7.1.2 TPA/56050 - 2015 DANDENONG ROAD CLAYTON - COMMUNITY CARE ACCOMMODATION AND APARTMENTS

EXECUTIVE SUMMARY

That Council resolves to issue a Notice of Decision to Grant a Planning Permit (TPA/56050) for the use of the land for community care accommodation, construction or extension of two or more dwellings on the land, buildings and works for a section 2 use, and creation or alteration of access to a road in a Transport 2 Zone at 2015 Dandenong Road CLAYTON 3167 subject to the following conditions:

GROUND FLOOR PLAN

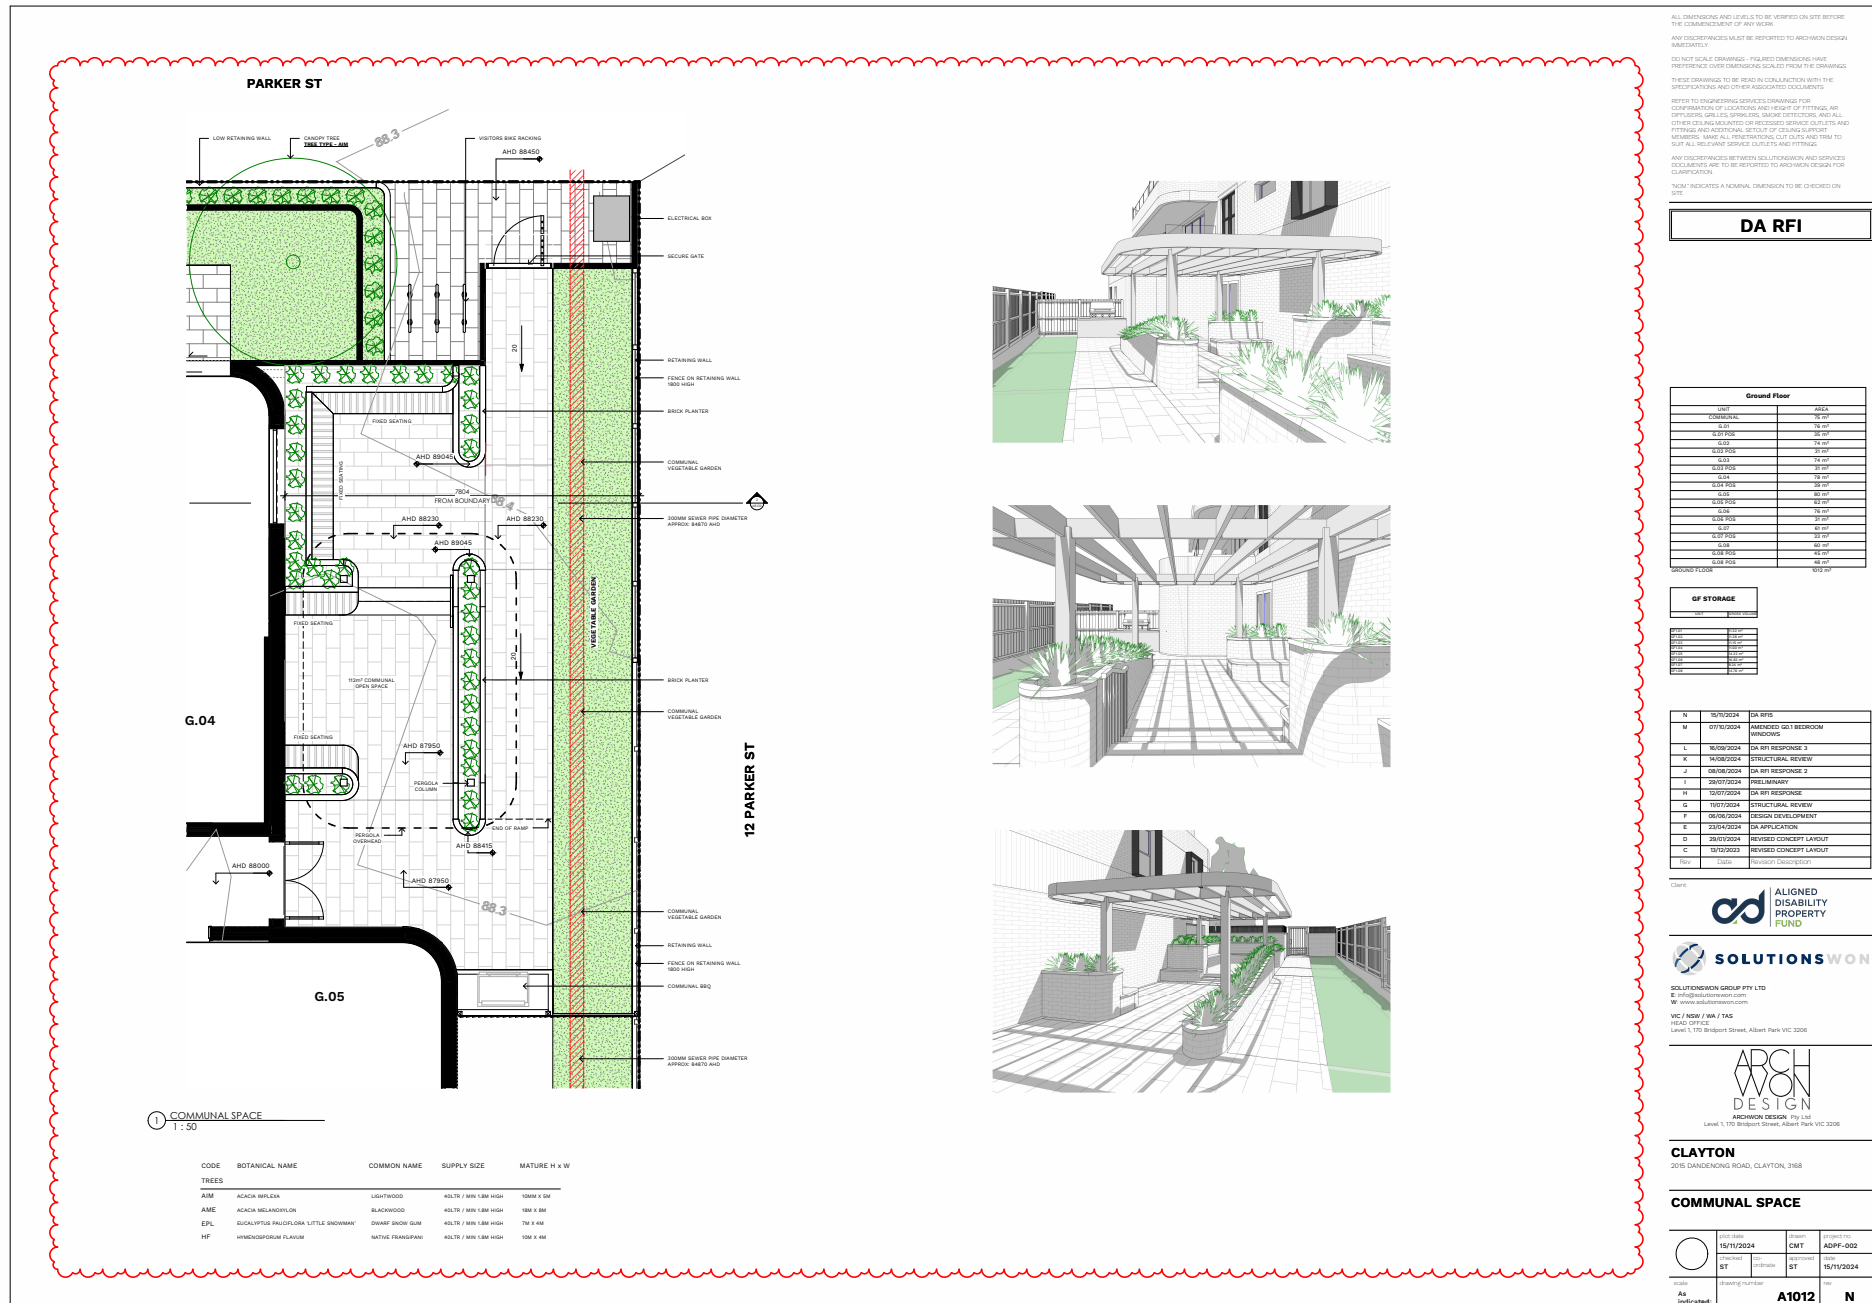
- a) Deletion of obscure glazing in the window of unit G.01 facing Dandenong Road.
 - b) The provision of acoustic glazing or other approved equivalent to windows over the basement entry to prevent a loss of internal amenity through noise.

The visible ground floor windows facing Dandenong Road in unit G.01 comprise obscure glazing and a bathroom window. This treatment is inconsistent with Standards B5 and B51 and does not reflect the typical façade fenestration in the area. It also prevents surveillance of the public realm. This should be modified to improve integration by permit condition.

Standard B15 details the setback of windows from common accessways to protect residents from vehicular noise. The bedroom window in unit G.07 and living room in G.08 open onto the basement entry. These windows have been provided to achieve compliance with natural ventilation Standard B49, however this does not apply to the community care accommodation units. There will be a detrimental impact of noise from the basement, particularly to the bedroom window facing Dandenong Road. The provision of acoustic glazing to these windows will provide for improved noise protection and can be provided by permit condition.

COMMUNAL SPACE

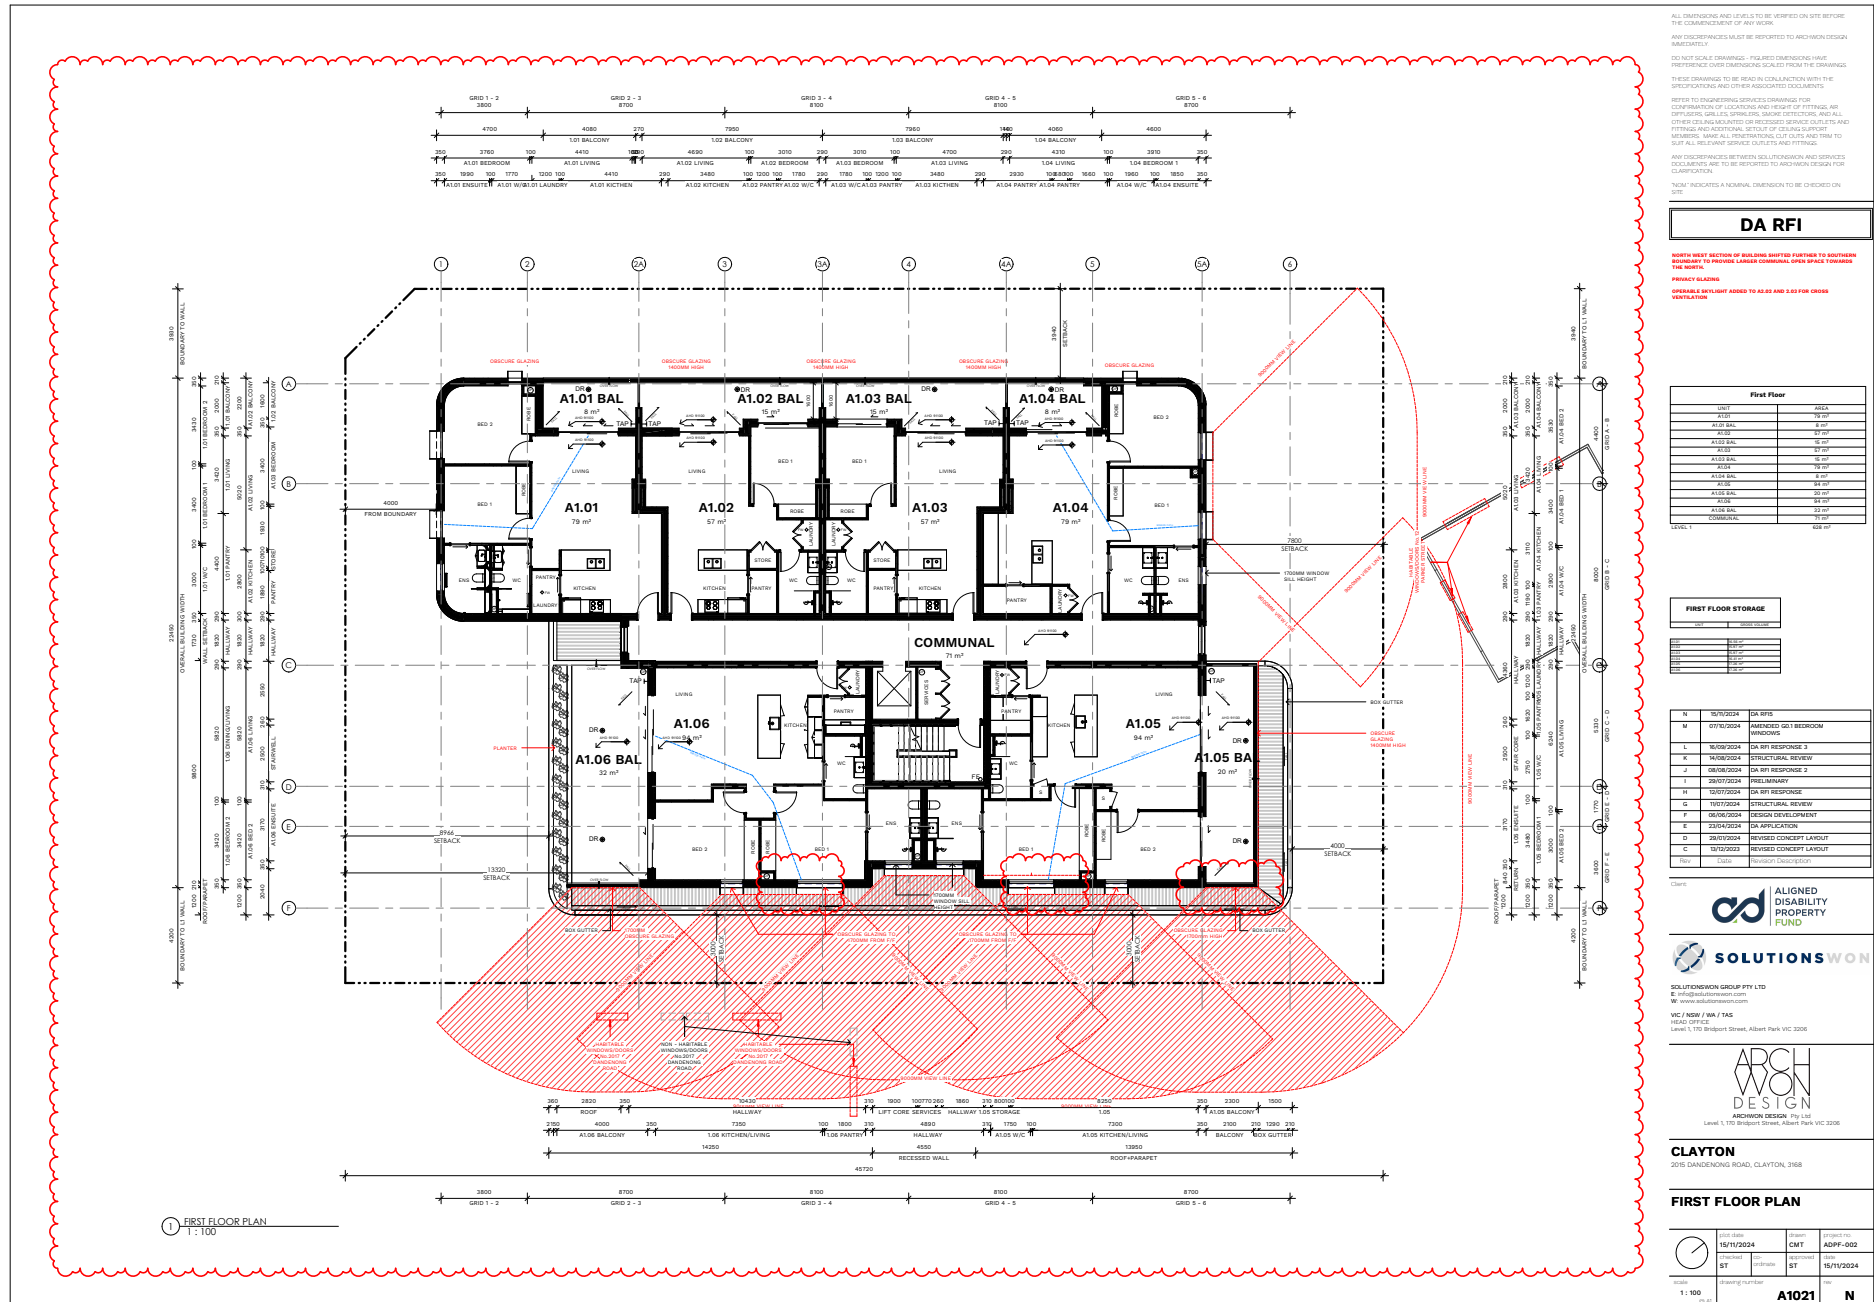
NORTH WEST SECTION OF BUILDING SHIFTED FURTHER TO SOUTHERN BOUNDARY TO PROVIDE LARGER COMMERCIAL OPEN SPACE TOWARDS THE NORTH.

PRIVATE GLAZING
 ORIGINAL PRIVATE GLAZING ADDED TO A1.05 AND A1.06 FOR CROSS VENTILATION

FIRST FLOOR PLAN			
Date Issued	Project	Drawn By	Checked By
15/11/2024	CMAT	ADPP-002	
15/11/2024	ST	ST	ST
15/11/2024			
Scale	Sheet Number	Sheet	Of
1:100	A1021	N

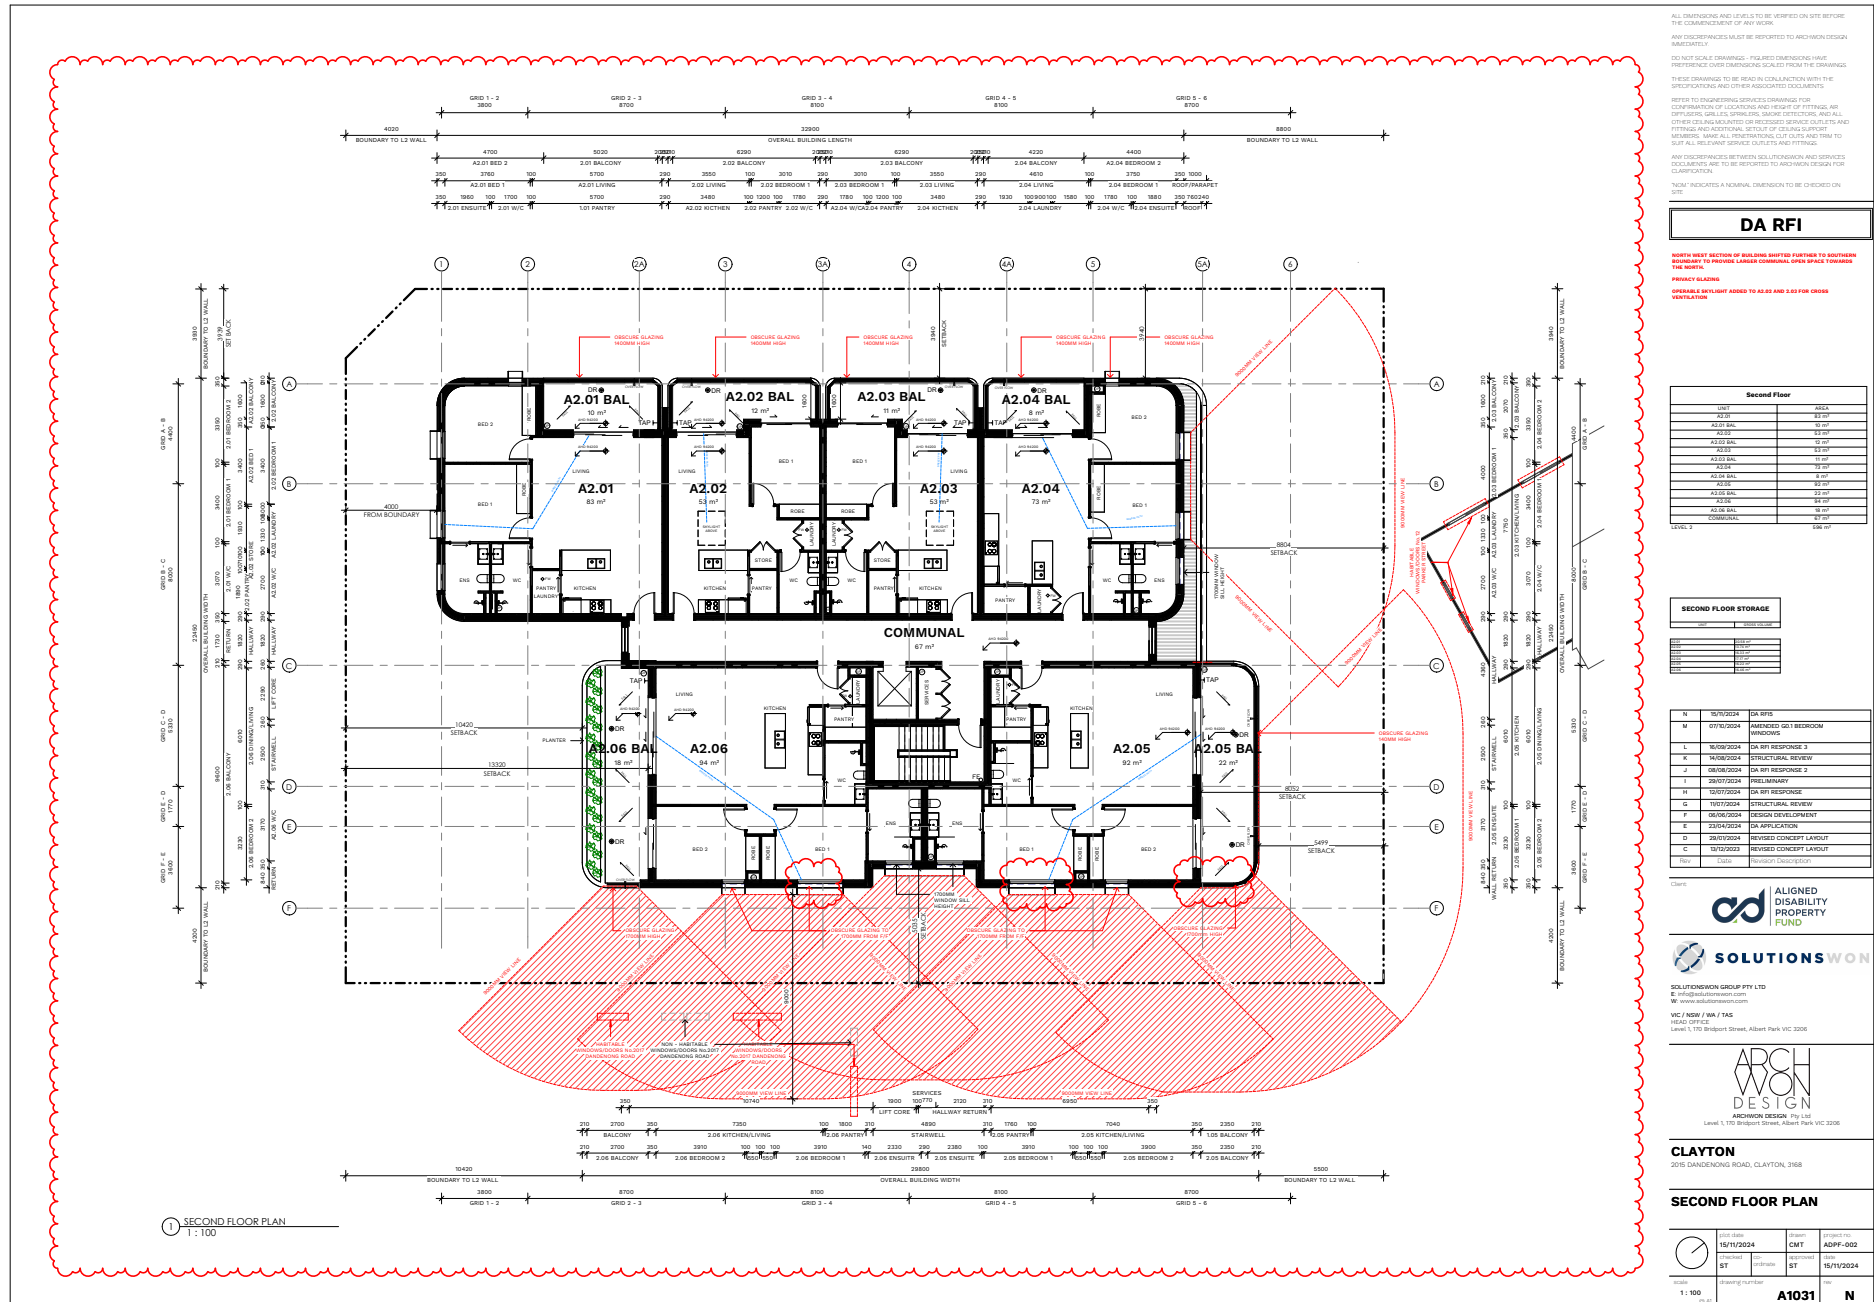
NORTH WEST SECTION OF BUILDING SHIFTED FURTHER TO SOUTHERN BOUNDARY TO PROVIDE LARGER COMMUNAL OPEN SPACE TOWARDS THE NORTH.
PRIVATE GLAZING
ORIGINAL WINDOW LIGHT ADDED TO A2.05 AND A2.06 FOR CROSS VENTILATION

Date Issued	Project	Project No.
15/11/2024	CMAT	ADPP-002
Drawn	Checked	Issue Date
ST	ST	15/11/2024
Scale	Drawing Number	Sheet
1:100	A1031	N

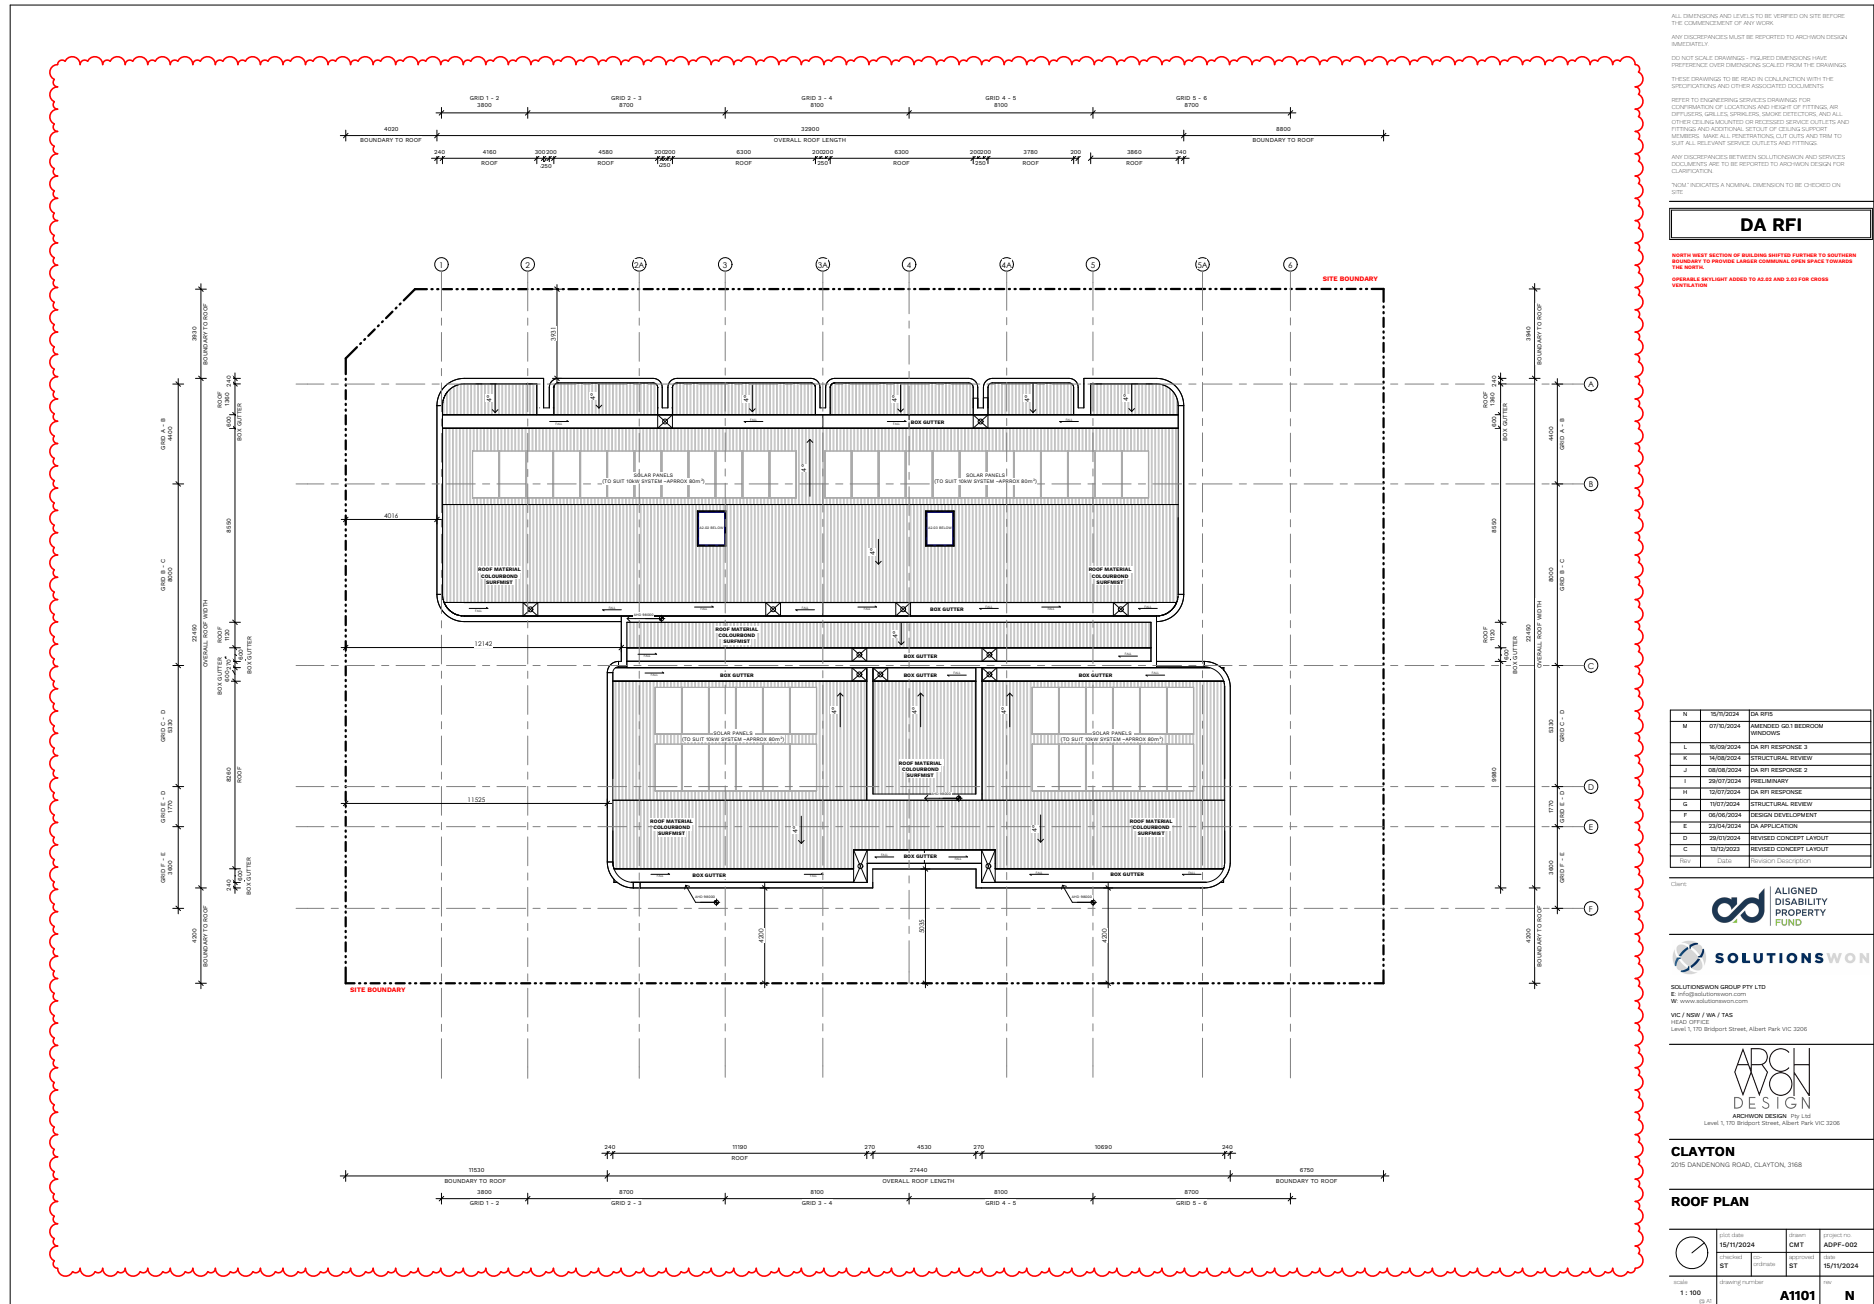
- BALCONY RAILINGS CHANGED TO OBSCURE GLAZING - SEE ENVELOPING SECTIONS
- OBSCURE GLAZING TO WINDOW PANELS BELOW L1M
- FRONT WALL REDUCED TO 0.9m IN AREA
- CANOPY TREE LOCATION CHANGED - SEE GROUND FLOOR PLAN
- BOUNDARY FENCE PANELS CHANGED TO 1800MM
- PLANTING AREA ADDED TO FRONT FACADE - SEE CLADDING LIAISON
- COMMERCIAL SIGN FACES ADDED TO SOUTH ELEVATION
- HALF OF PROPOSED FRONT SETBACK REDUCED TO 4M FROM BOUNDARY
